APS Renovation / Redevelopment project 1 February 2019 Presentation for the NCCA

Major concerns raised by Arch. Gelo Manosa ON BEHALF OF National artist Francisco Manosa with reference to the 11 December 2018 design of EPEA

- 1. EPEA's revised design, 30 Jan. 2019 [comparison of existing vs. proposed design]
- 2. EPEA's alternative roof design [31 Jan. 2019] for Lopez/Rockwell corner to closely approximate the original design intent of Arch. Francisco Manosa. [design is a meter beyond height limitation]

GENERAL REMODELING

ROOF PLAN

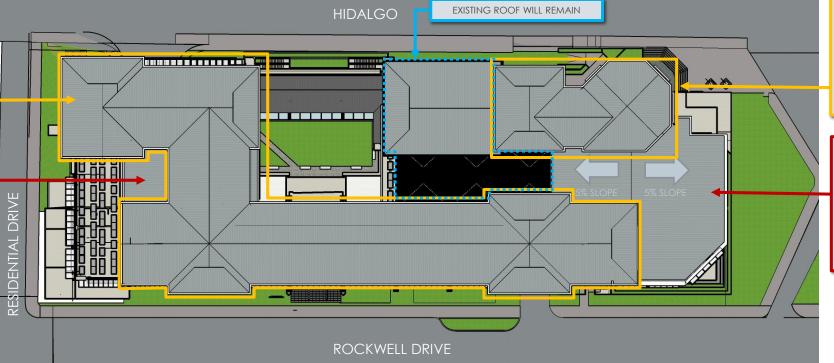
- Roof design [nipa hut / salakot / pitched roof]
- 2. Slanted windows
- 3. Banawe roof material
- 4. Finials

BANAWE ROOF

- SAME AS MATERIAL AS ORIGINAL

LONG SPAN HI RIB ROOF

- RECOMMENDED ROOFING SHEETS FOR LONG AND LOW-SLOPE ROOFS

BANAWE ROOF

- SAME DESIGN AND MATERIAL AS ORIGINAL
- RECOMMENDED MINIMUM SLOPE FOR BANAWE ROOF (AS PER MANUFACTURER): 21.26%

LONG SPAN HI RIB ROOF

- RECOMMENDED ROOFING SHEETS FOR LONG AND LOW-SLOPE ROOFS
- CANNOT BE SEEN FROM THE STREET
